1. **Committee of the Whole – July 20, 2017**
2. **Development Variance Permit Application No. 00192 and Development Permit with Variances Application No. 00033 for 1421 Fairfield Road (Fairfield)**

4.1 Development Variance Permit Application No. 00192 for 1421 Fairfield Road (Fairfield) and Development Permit with Variances Application No. 00033 for 1421 Fairfield Road (Fairfield)

1421 Fairfield Road
Development Permit with Variances #00033

Rear-facing upper storey windows are transom style to reduce impacts.

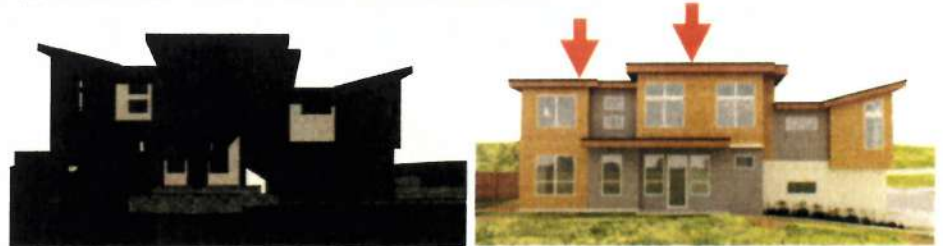
Response The rear face of the homes on Lots F and E have been reworked, *replacing standard windows with high 'transom'-style windows* on the upper floors. The applicant has also committed to work with the neighbours to improve fencing and vegetated screening.

Moreover, further engagement provided the opportunity to discuss the actual impacts: For example, the neighbouring houses on Masters Road are at a significantly higher elevation, greatly reducing privacy impacts, and the houses on Faircliff Lane have significant screening in their rear yards and limited rear-facing windows.

Proposed two-storey homes will be expressed as two storeys, not three.

Image comparing proposed lots and true panhandle (access only frontage).

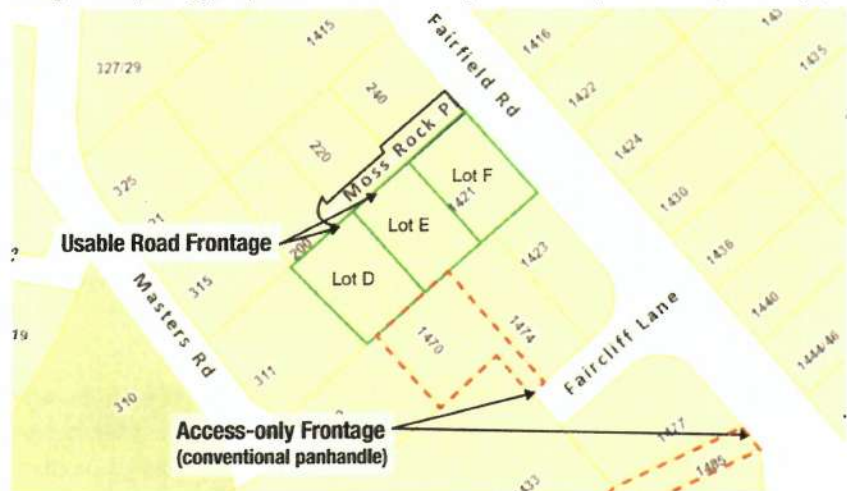
Neighbours Several neighbours took exception to the height variances for Lots D and E, largely based on principle. Once the above/below was explained, neighbour concerns were significantly reduced.

Response Lots D and E *do not function as panhandle lots* and, upon approval, all three lots will become part of the existing Moss Rock Place strata. Thus, the variances proposed to the Schedule H regulations hold significant merit relative to a 'true' panhandle context.
